Cust. P/N: PC005A

N.E. Ref: U1705-3

ENGINEERING ENQUIRIES

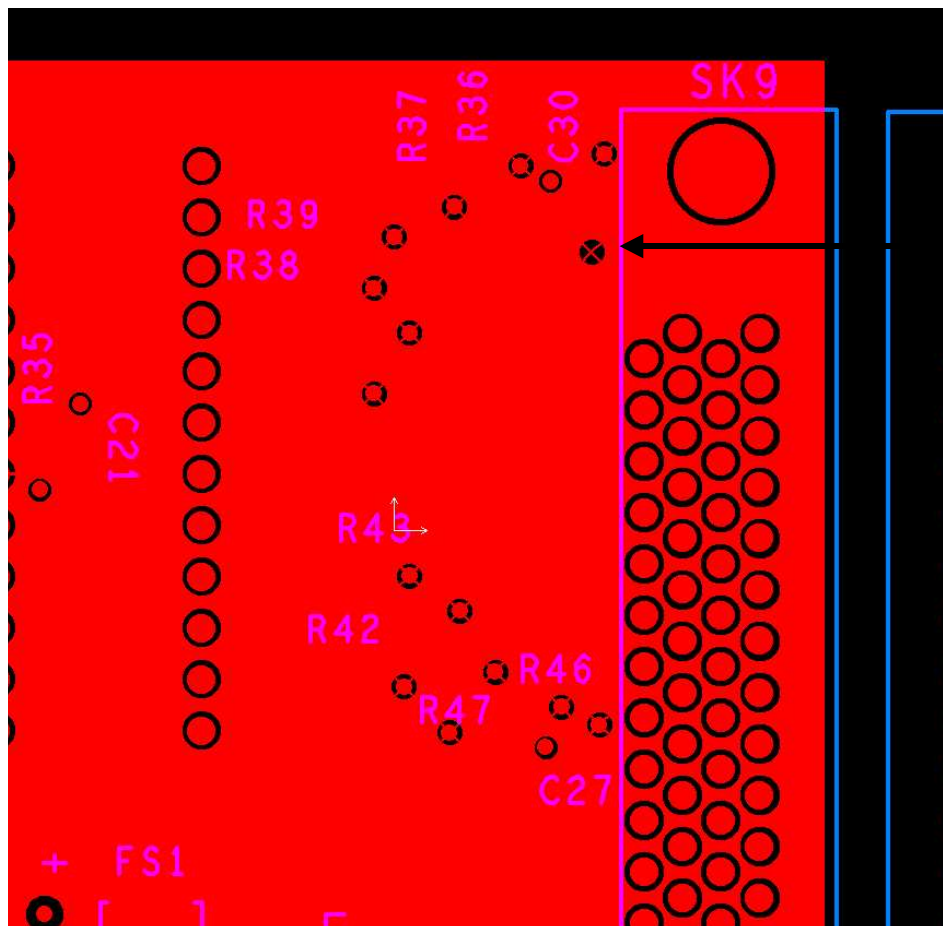
Thermal will not
connect. No pad.

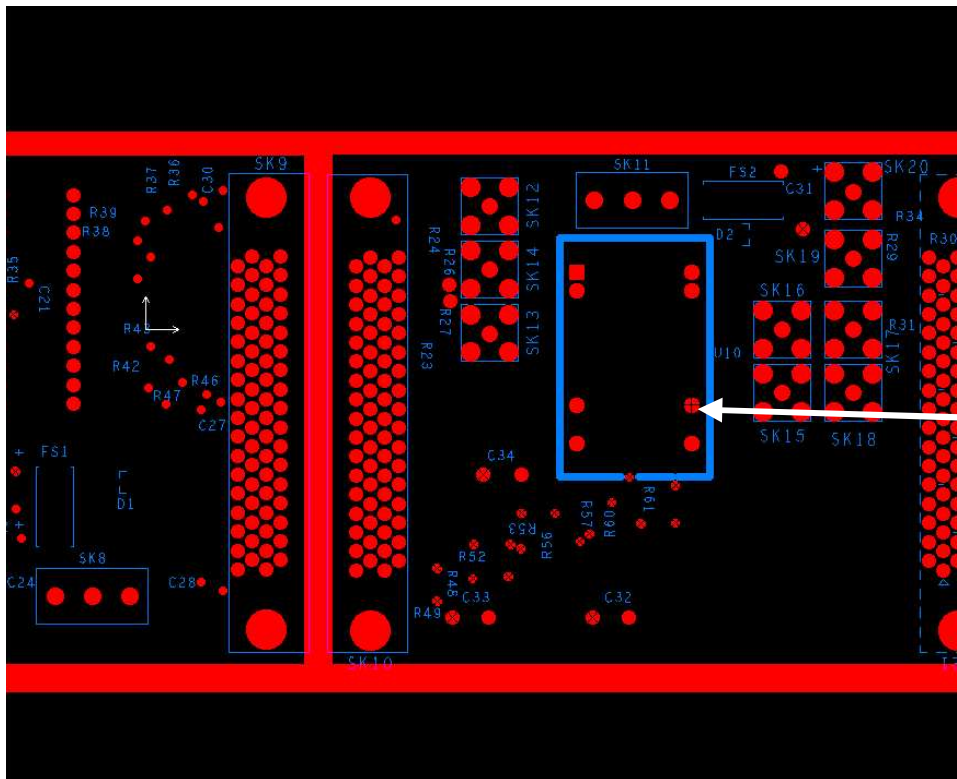
GND

The same as gnd
layer

VCC
